Fakhruddin Textile Mills Ltd. (9290)

Ghargharia, Master Bari, Kewa, Sreepur, Gazipur, Dhaka.

23.AUGUST.2014

Identified Priority 1 Concerns

Building 3

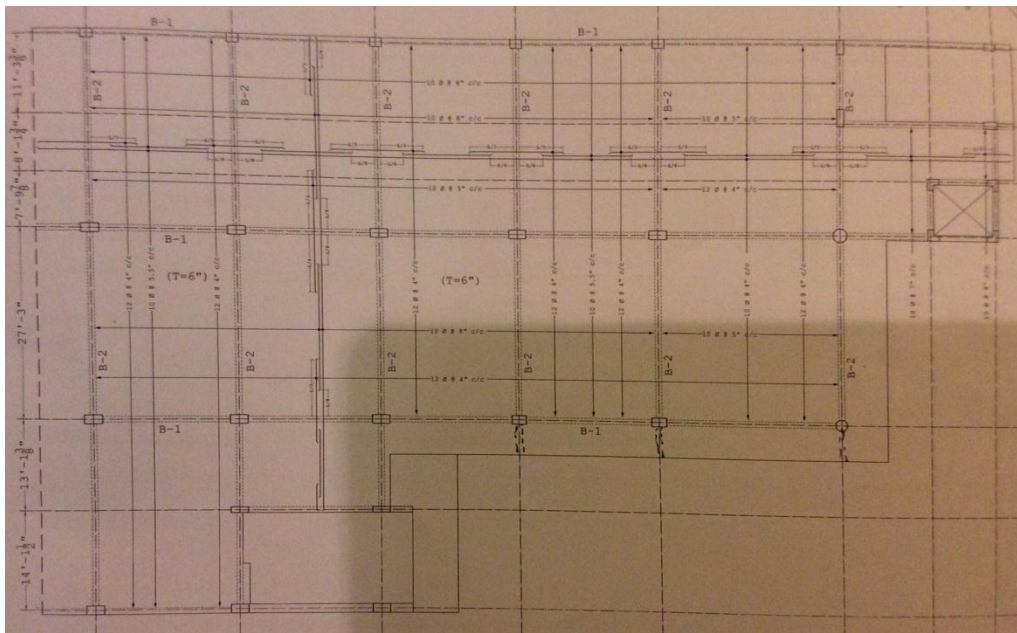
Produce Loading Plans for each floor of each building.

Based on our calculation for the column load rundowns, the allowable live load for Building 1, 2, 3, 6 is around 3.0kPa.

Buildings 5 and 7 appear to have a floor capacity of 7.5kPa (for machines ?). However, a Structural Engineer needs to review and check the full beam and slab system to assess the loading.
